1990 - 1992 Corvette ZR-1: Service Bulletin: No Start Condition (Replace Starter)

Subject: NO START CONDITION (STARTER CORROSION-REPLACE STARTER)

Model and Year: 1990-1992 Corvette, Engine Code J (LT5)

Bulletin Number: 92-307-6 - (09/21/1992)

Figure 1

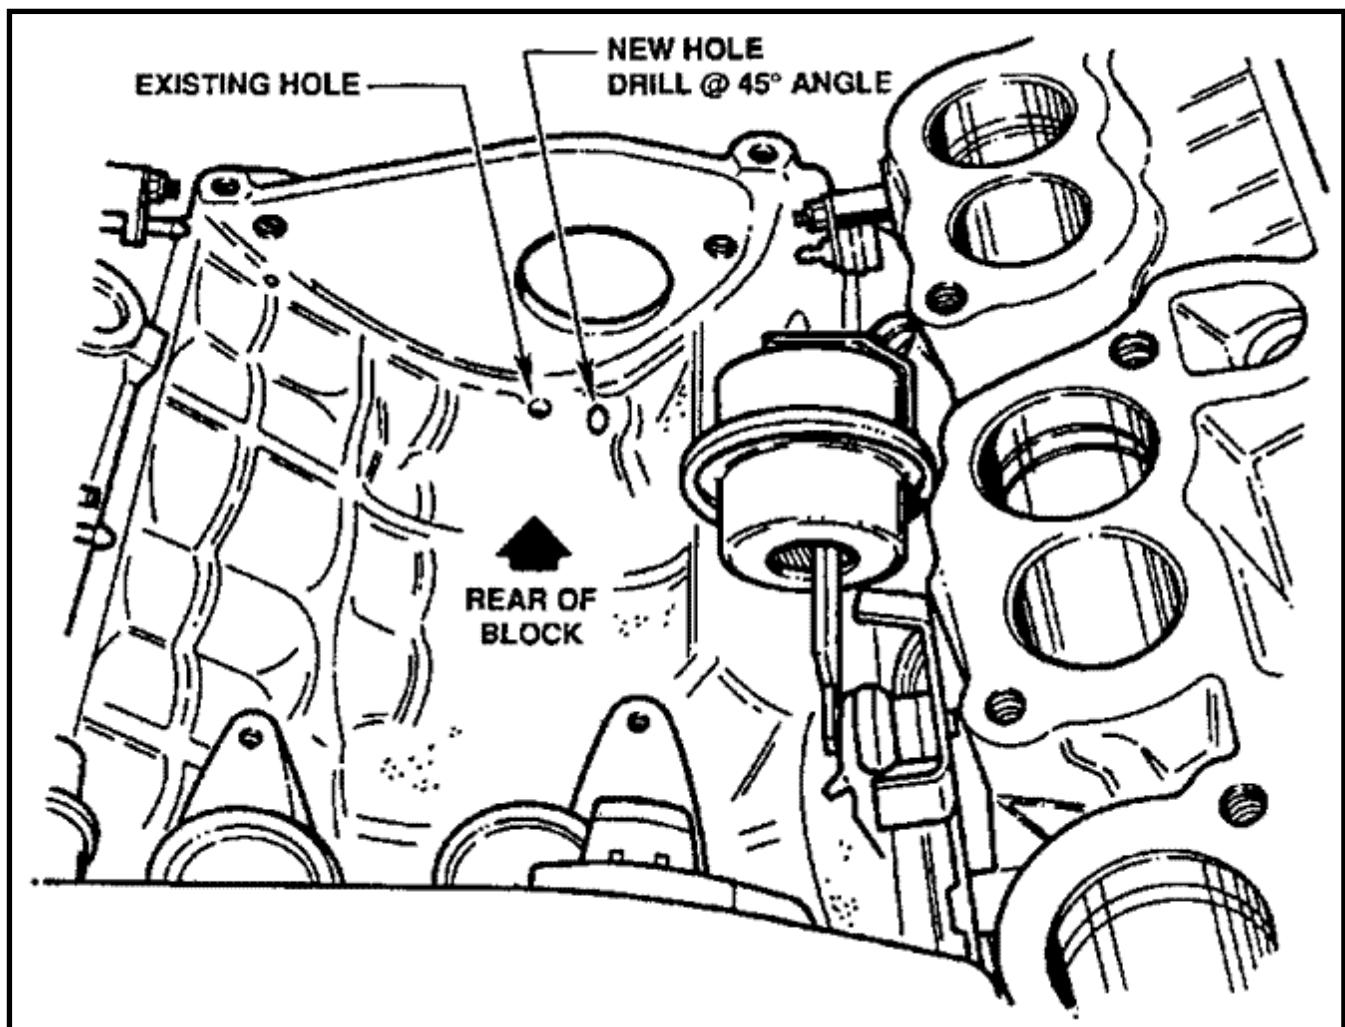
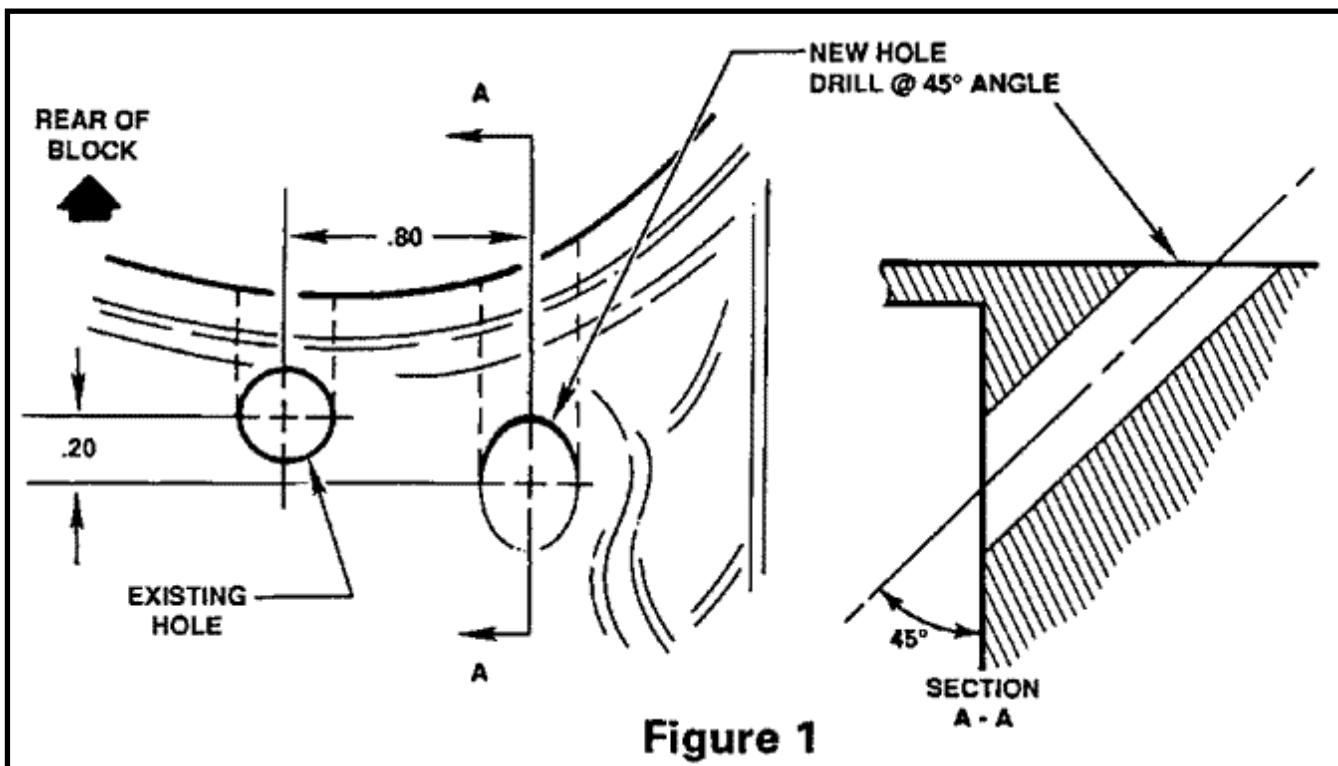
Some ZR1 Corvettes may exhibit a no start condition due to starter corrosion. This condition is most likely to occur after the engine has been washed.

The starter on an LT5 engine is mounted in the engine "vee." A drain hole and drain tube are located at the rear of the engine valley. While washing the engine, debris may settle in the engine "vee" and block the drain system.

- 1 . Remove the old starter.
2. Clean any blockage in existing drain system.
3. Drill a 3/8" diameter hole through the engine "vee" to the back of the engine, allowing drainage (see Figure 1).

4. Install new starter, p/n 10455704.
